IN REPLY REFER TO:
NCPC File No. Z.C. 08-01

**SOUTHEAST FEDERAL CENTER OVERLAY REVIEW
PARCEL D, SQUARE 826**

M Street and 4th Street, SE
Washington, D.C.

Delegated Action of the Executive Director
MAR 27 2008

Roof Plan

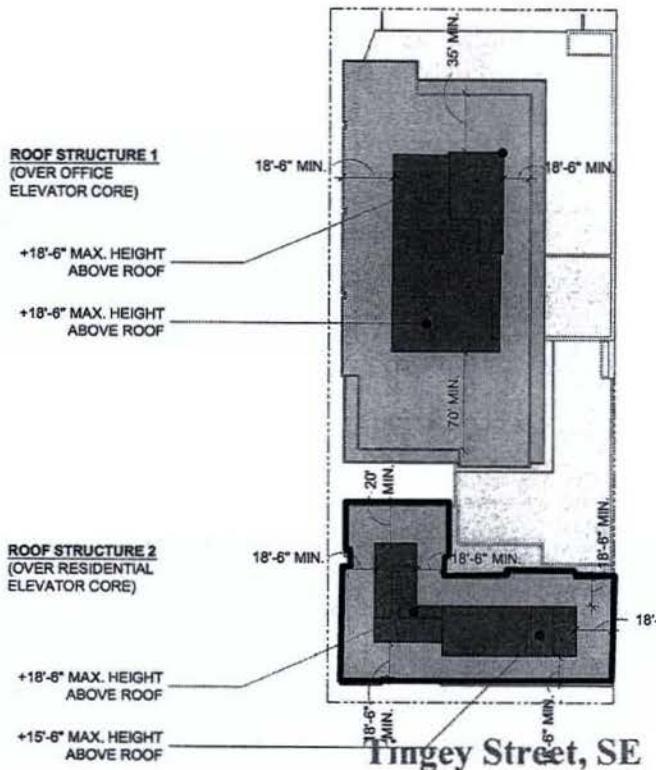
At the July 12, 2007 Commission meeting, NCPC approved the 35% design submission for Parcel D. The submission included the Tingey Street perspective and the roof plan shown above.

If constructed according to the plans shown herein, the proposal would not be inconsistent with the Comprehensive Plan for the National Capital nor have an adverse affect on any identified federal interests. The proposal would comply with the Height of Buildings Act of 1910 because rooftop mechanical penthouses are set back from all of the exterior walls of the buildings a distance equal to their heights above the adjacent roofs.

Alternative designs requiring setback relief for roof structures, with rooftop structures that are not set back from all exterior walls, would violate the Height of Buildings Act, which allows mechanical penthouses above the limit of height only if they are set back from all exterior walls a distance equal to their heights above the adjacent roofs.
